Access Compliance Report

Public Rights-of-Way

(Curb Ramps)

Intersection ID: 10036601	Main Street: RUSHMORE_DR	Cross Street: N/A	Location: NW
ADA ID: 8376CDAA0370	Ramp Type: PerpDiag	Initial Pass/Fail: Fail	Overall Compliance: No
		Severity Score: 37.5

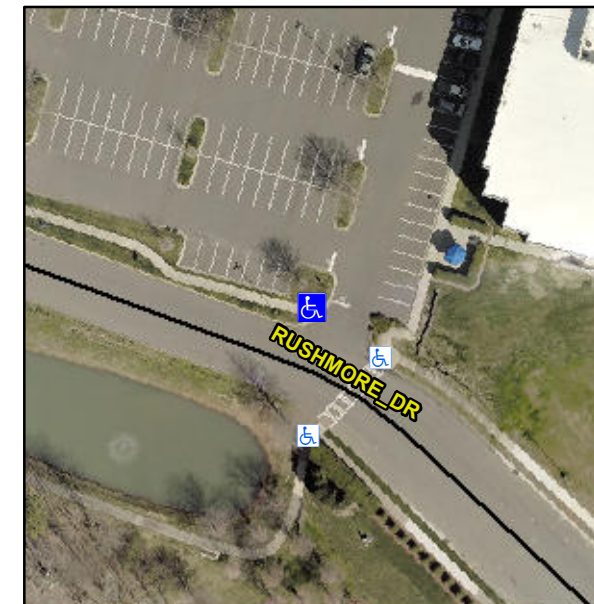
R304.2.2, R304.5.3

Compliance	Description	Data	Compliance	Description	Data
N/A	Ramp Length (in)	83.0	No	Ramp Slope (%)	12.1
Yes	Ramp Width (in)	48.0	No	Ramp XSlope (%)	6.3
N/A	Flare Type LT	N/A	N/A	Flare Type RT	N/A
N/A	Flare Slope LT (%)	N/A	N/A	Flare Slope RT (%)	N/A
N/A	Flare Traversable LT?	N/A	N/A	Flare Traversable RT?	N/A
N/A	Landing Length (in)	N/A	N/A	DWS Provided?	N/A
N/A	Landing Width (in)	N/A	N/A	DWS Contrast?	N/A
N/A	Landing Slope (%)	N/A	N/A	DWS Length (in)	N/A
N/A	Landing X Slope (%)	N/A	N/A	DWS Full Width?	N/A
N/A	Landing Curb? (Y/N)	N/A	N/A	DWS Offset (in)	N/A
N/A	Shared Landing?	N/A			
N/A	Gutter Ponding?	N/A	N/A	Gutter Slope (%)	N/A
N/A	Gutter Lip Ht (in)	N/A	N/A	Gutter X Slope (%)	N/A
N/A	Painted X Walk1?	No	N/A	Painted X Walk2?	No
	X Walk 1 Direction	To SE		X Walk 2 Direction	To NE
N/A	X Walk 1 Width (in)	N/A	N/A	X Walk 2 Width (in)	N/A
	X Walk 1 Slope (%)	5.7		X Walk 2 Slope (%)	3.6
	X Walk 1 X Slope (%)	2.9		X Walk 2 X Slope (%)	5.9

Remove & Replace Curb Ramp With Two New Directional Ramps or Equivalent.
